# **ROCKY FLATS ENVIRONMENTAL TECHNOLOGY SITE**

## **771 Closure Project Decommissioning Operations Plan Modification 3 and Proposed Action Memorandum for Under Building Contamination Remediation**

**February 28, 2001**

Figure 2. 771 Closure Project Organization

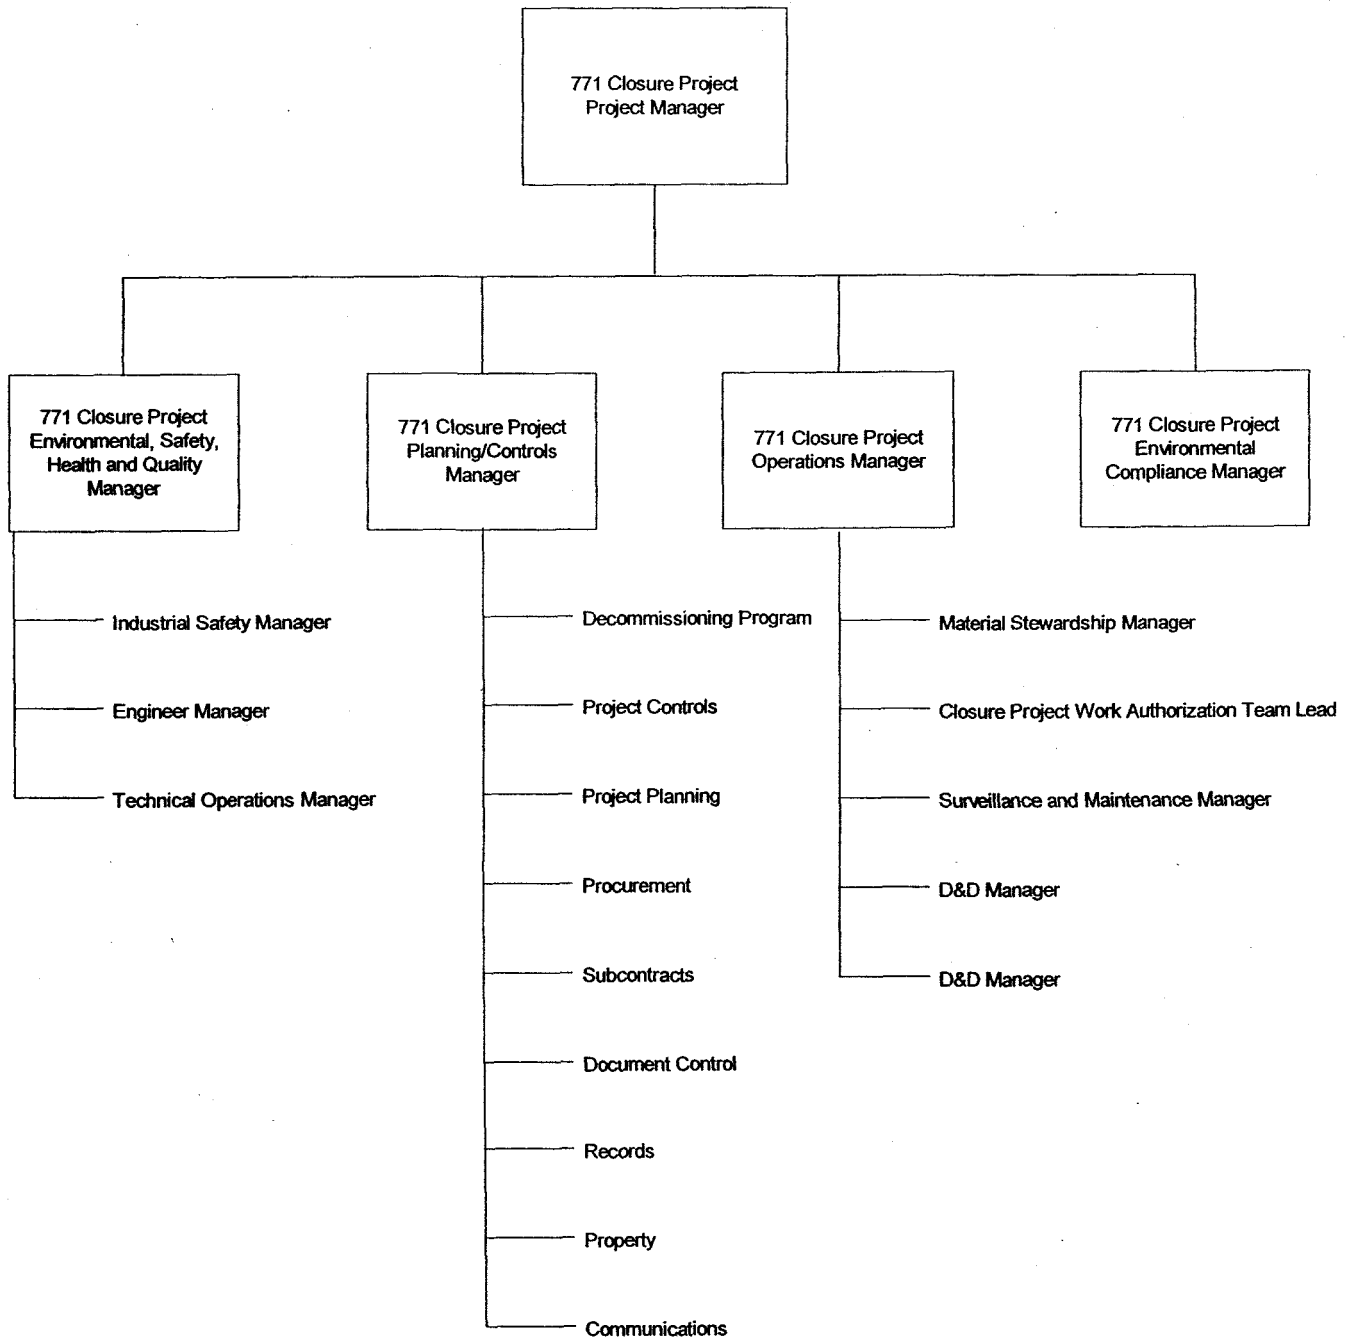
3	<p>Page 10, Figure 2. 771 Closure Project Organization. Why does the project require two D&amp;D Project Managers?</p> <p>This section provides a brief description of the 771 Closure Project organization structure, functions, and interfaces as they pertain to facility management and decommissioning. The organizational structure is not an enforceable part of the DOP. The information requested is too detailed for the DOP modification.</p>
4	<p>Page 17, 3.1.2 Physical Interfaces. Define the interface between Building 771 personnel and Building 776 personnel when the tunnel is being remediated.</p> <p>The tunnel will be dispositioned by the 771 Closure Project. Prior to initiating decommissioning activities, a barrier will be placed at the 776 opening to control the work area and prevent cross contamination.</p>
5	<p>Page 20, 4.3 Dismantlement Sets and Decommissioning Areas. Broomfield is concerned with the concept of having only Building Trades working in Areas with removable contamination less than 2,000 dpm without the support of Steelworkers, which have the process knowledge of the facility and known hazards associated with dismantlement of equipment. Clarify the need to distinguish between a dismantlement work set and a decommissioning area. All steps must be taken to protect the workers from potential situations that could lead to a plutonium uptake.</p> <p>The distinction between sets and areas is made for work scope clarification and is based on the Project Labor Agreement. Work activities will be planned and executed in accordance with the RSOP for Facility Component Removal, Size Reduction, and Decontamination Activities, which is incorporated into the DOP through reference.</p>
